**Supplemental Environmental  
Impact Statement**

**WAIMANALO AGRICULTURAL PARK**

**PHASE II**

**FARM LOT SUBDIVISION**

**EXHIBIT II**  
**WAIMANALO AGRICULTURAL PARK**  
**PH. II - FARM LOT SUBDIVISION**  
**LOCATION MAP**

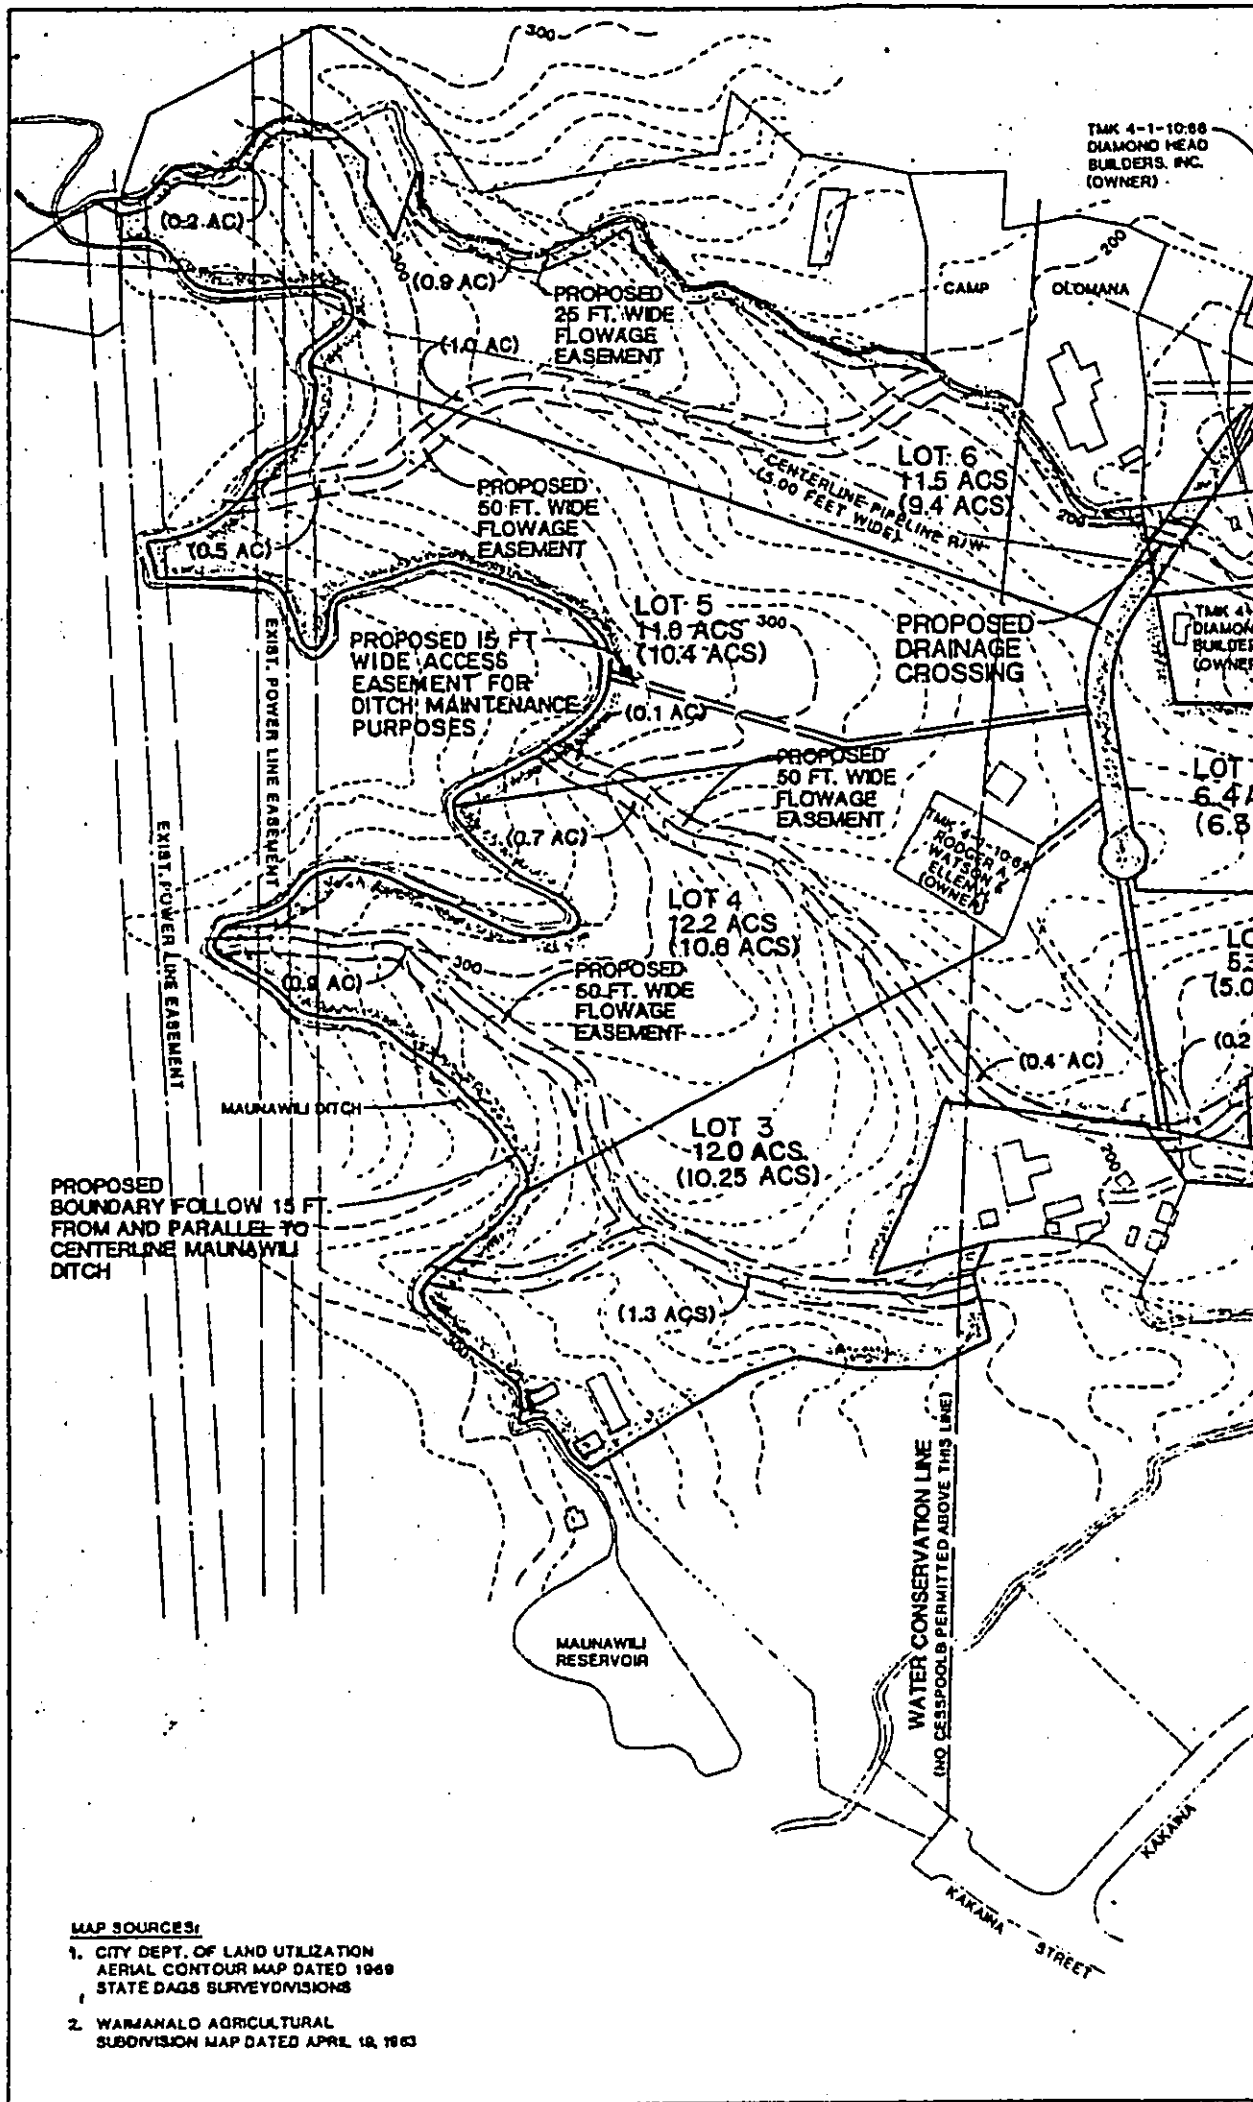
1. The spelling of the HECO substation located near the Waimanalo Reservoir, and listed in Exhibit II is incorrect. The correct spelling should be "Aniani".

**EXHIBIT III**  
**WAIMANALO AGRICULTURAL PARK**  
**PH. II - FARM LOT SUBDIVISION**  
**SITE PLAN**  
 PREPARED BY **KAKIANA & ASSOC., LTD**  
 APPROX SCALE IN FEET DATE, JULY 6, 1987

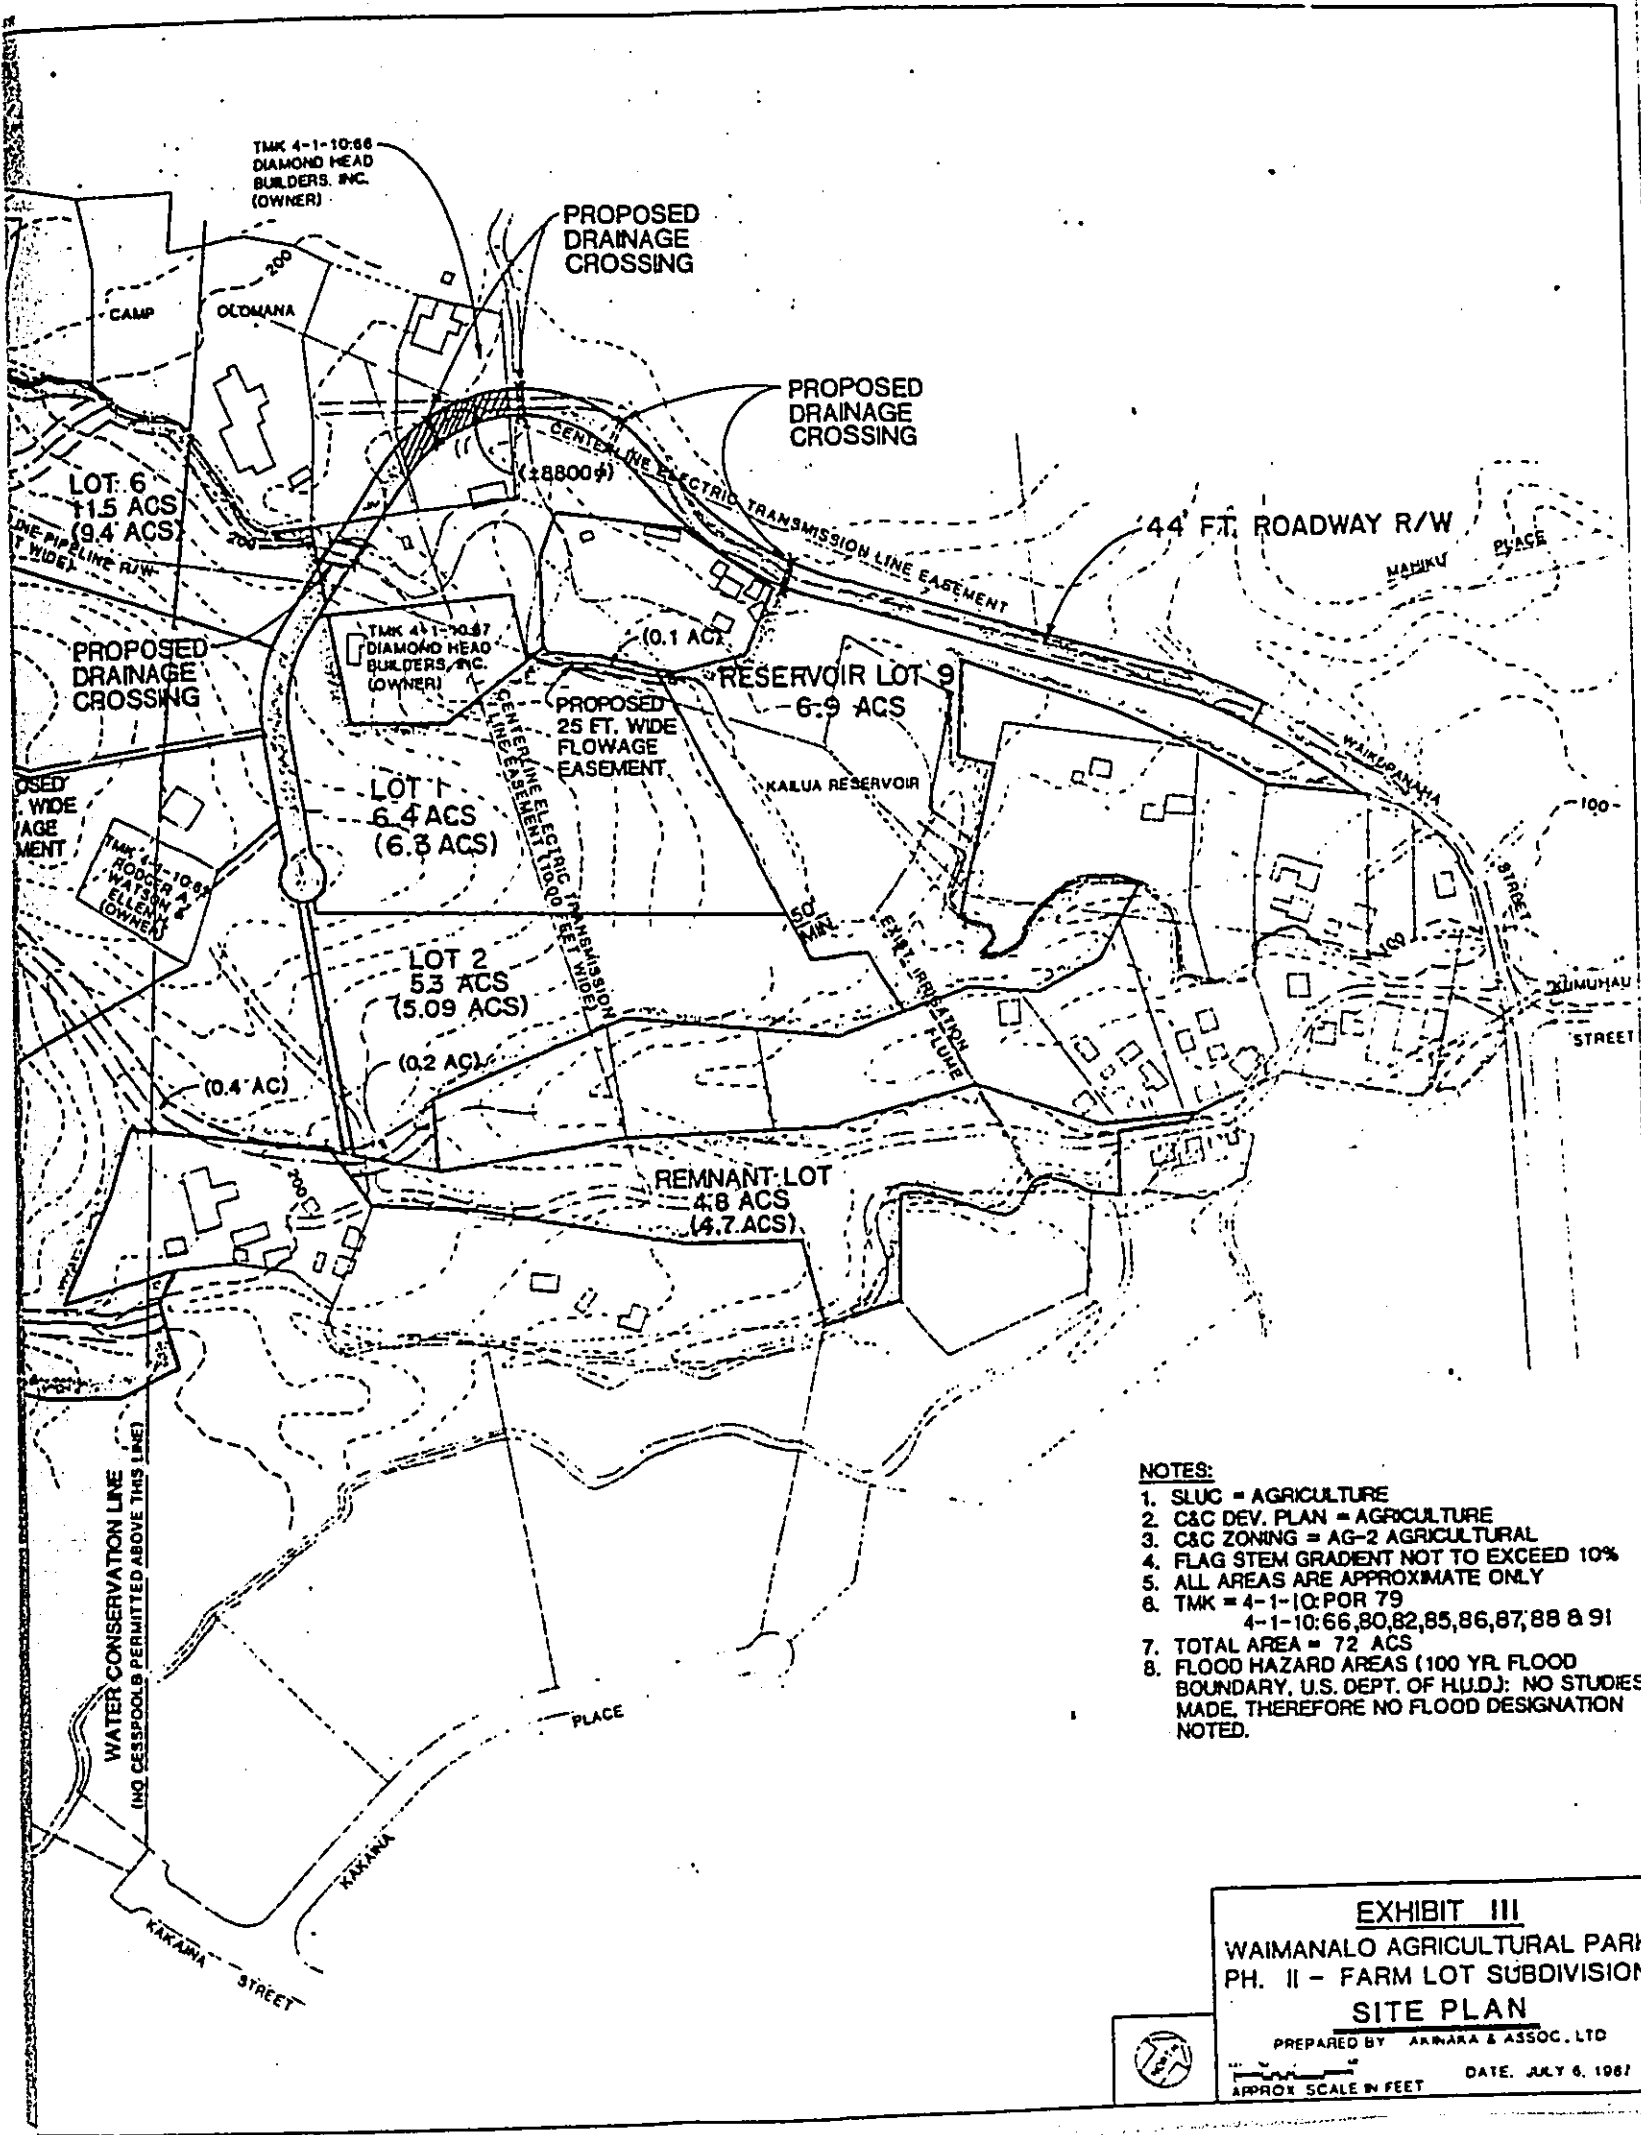
The Site Plan Map, Exhibit III of the EIS, shows a remnant lot with a long, long extension to the cul-de-sac of the proposed roadway into the project area. The remnant lot itself lies along and is bisected by the present roadway which serves the approximately 40 homes, including the Watson residence, which are located within or abut the project area on the southeastern and eastern side. The present roadway is accessed from Waikupanaha Street where Kumuhau Street dead ends. The long extension of the remnant lot to the cul-de-sac is therefore not self-explanatory. What reason is there for providing this extension?

The extension is required to provide access to Remnant Lot 10. This access is required by City and County of Honolulu's Department of Land Utilization.
